**REPORT ON
SELECTION OF REMEDY
AES PUERTO RICO – AGREMAX™ STAGING AREA
GUAYAMA, PUERTO RICO**

by
Haley & Aldrich, Inc.
Cleveland, Ohio

for
AES Puerto Rico LP
Guayama, Puerto Rico

File No. 133136-004
June 1, 2020

FIGURE 1-2

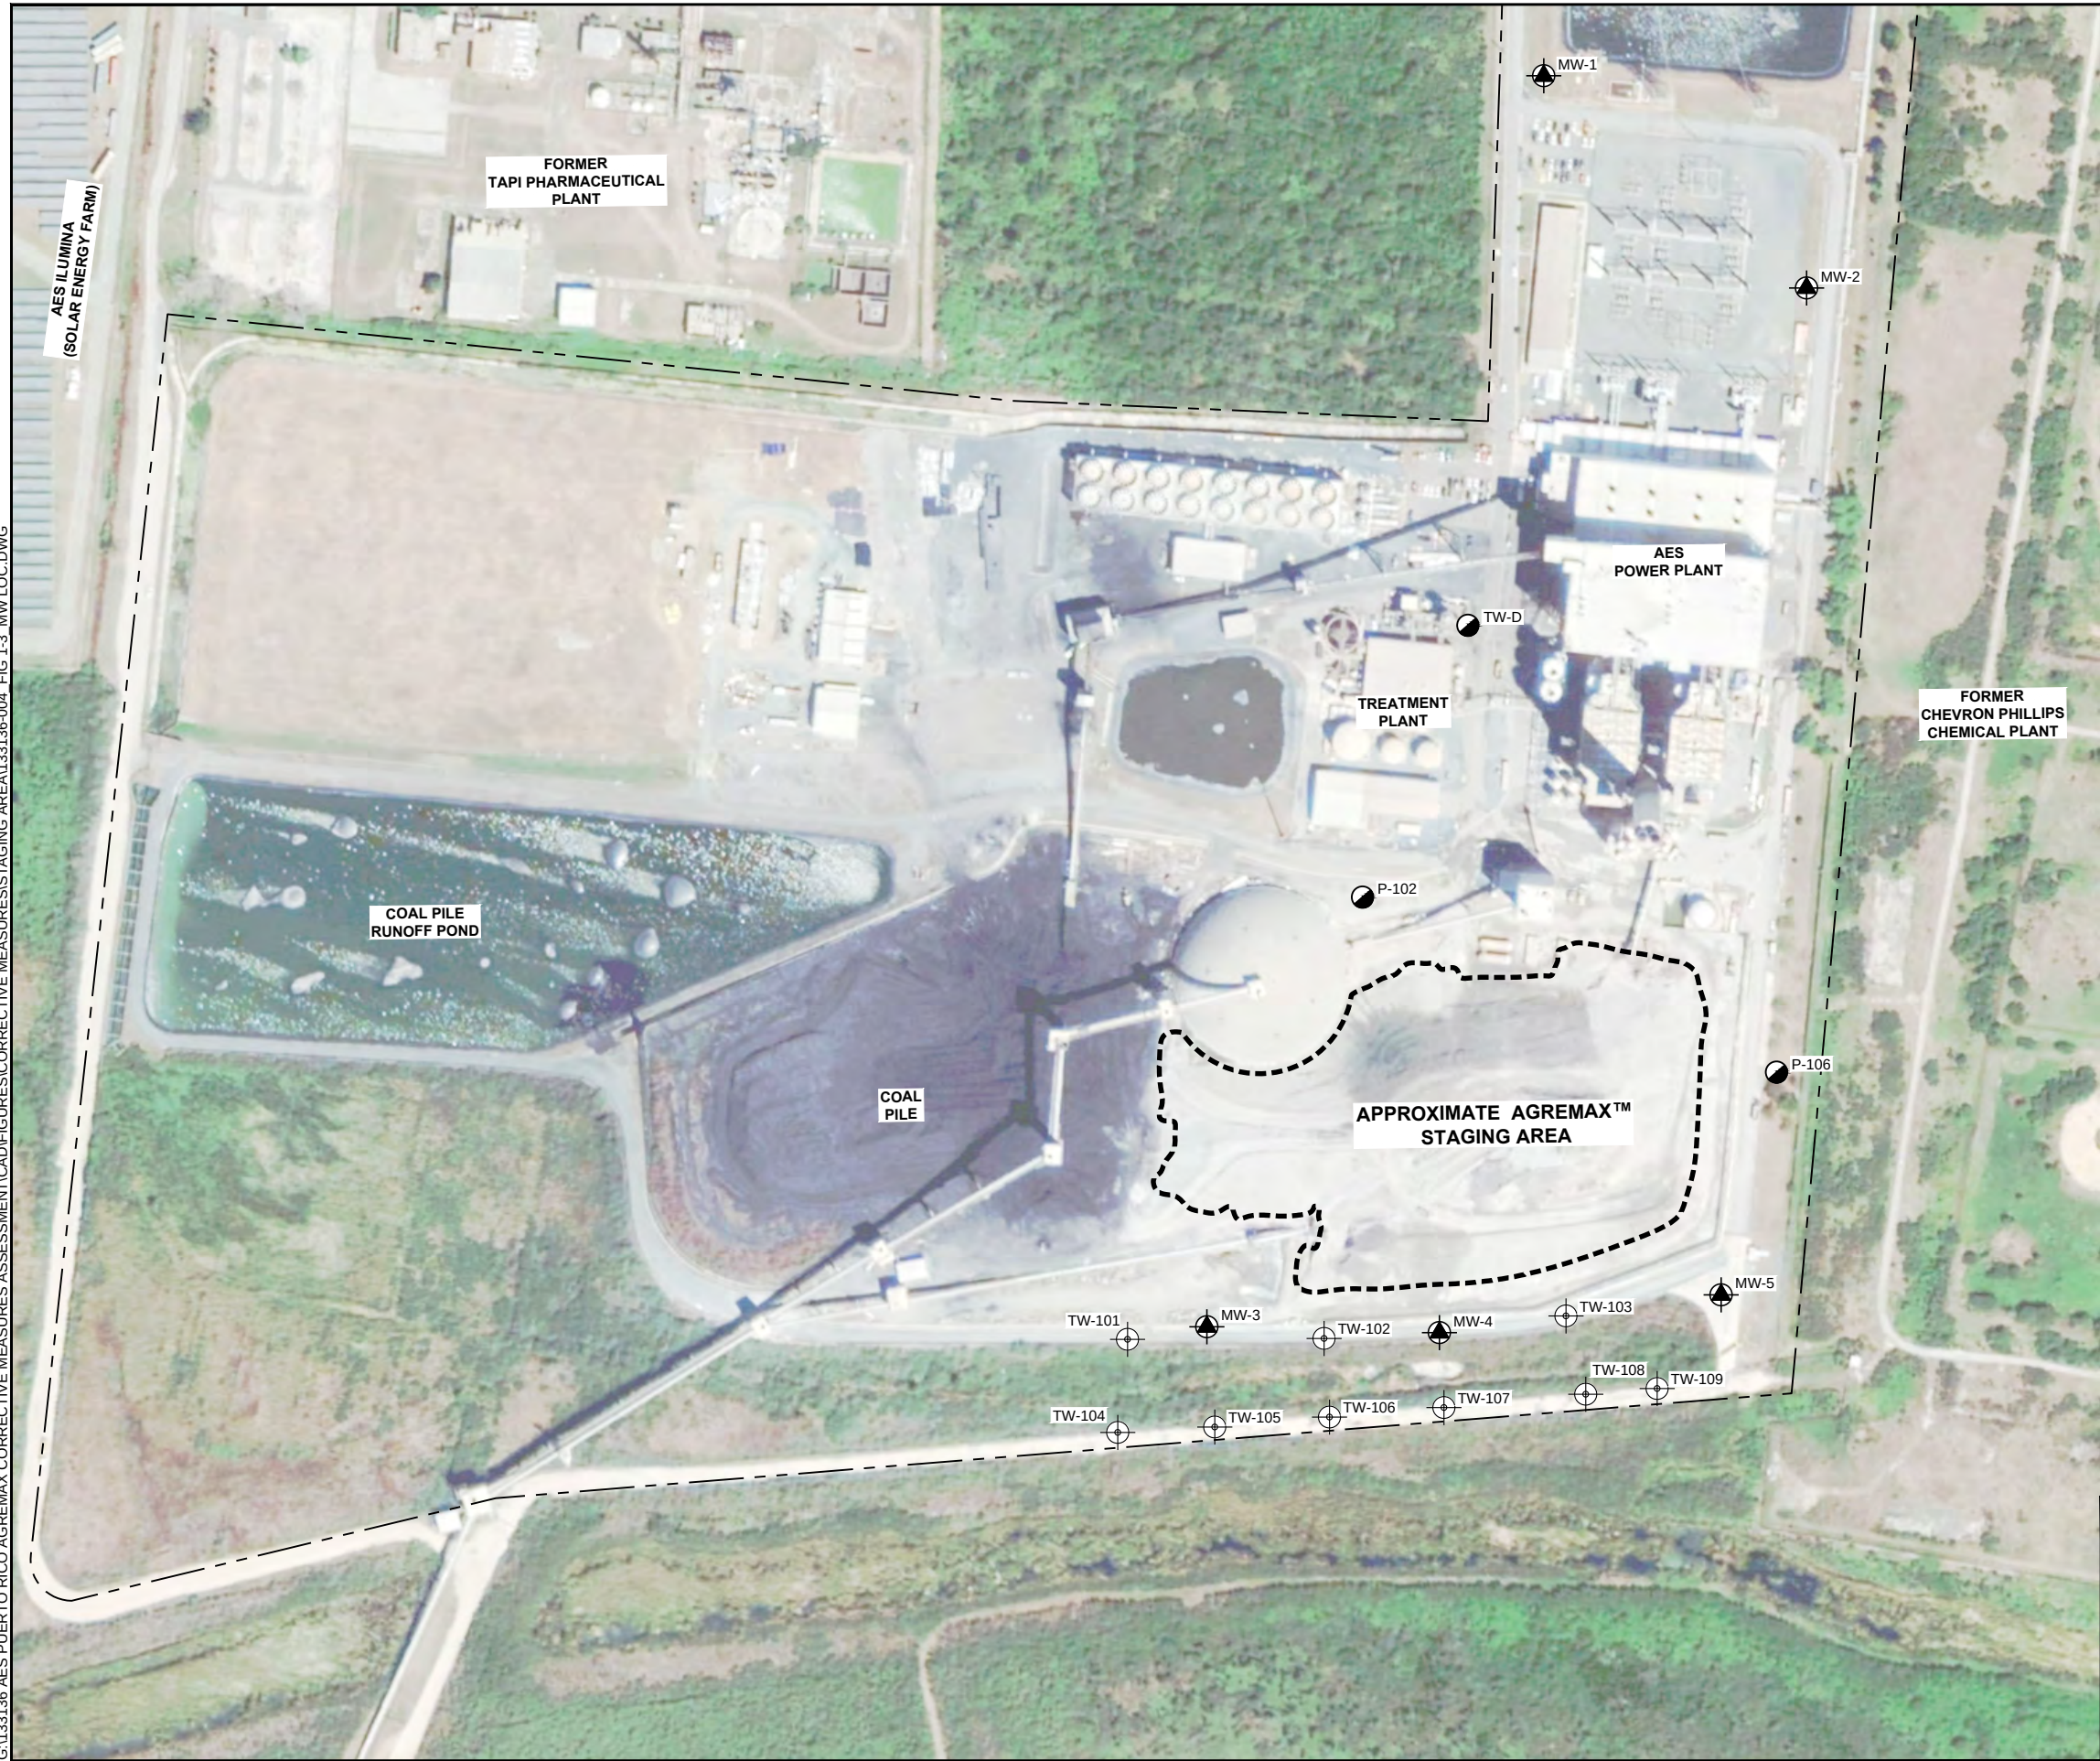
RESPONSE: The general groundwater flow direction beneath the AGREMAX™ Staging Area is shown in Figure 1-2 of the CMA report. The horizontal extent of the CCR constituents that exceed the site-specific GWPS has been determined, as shown in Figure 2-1 of the CMA report. Although the Site is close to the coast, the site water levels have not been found to be affected by tidal fluctuation. It is expected that the shallow groundwater flow will remain shallow before it reaches the intertidal zone, as shown in Figure A-3 in Appendix B of the CMA report. In addition, as described in Section 4.1 of the CMA report, the impacted shallow aquifer has been bounded by a layer of stiff clay of high plasticity. Therefore, the impacts of the Staging Area will remain in the shallow aquifer.
